Petition Number: 2023-046

From: Jake Carpenter, PE Reviewer: Natalie King, PE

Revision Log:

General Review Information

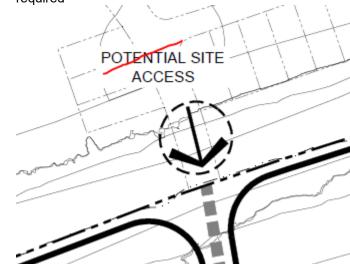
6. Outstanding Issue 8/24/23: Remove this intersection, and ensure all future horizontal curves meet the minimum CDOT standard of 150' radius.

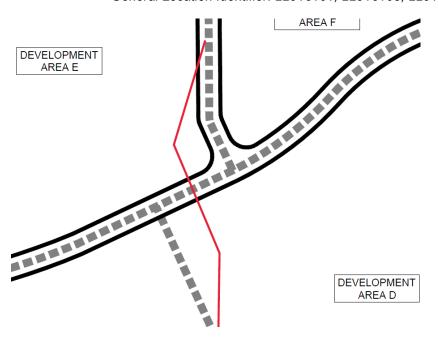
8. Outstanding Issue 8/24/23: The horizontal curves pictured below need to have a minimum 50' separation to meet minimum CDOT standard.
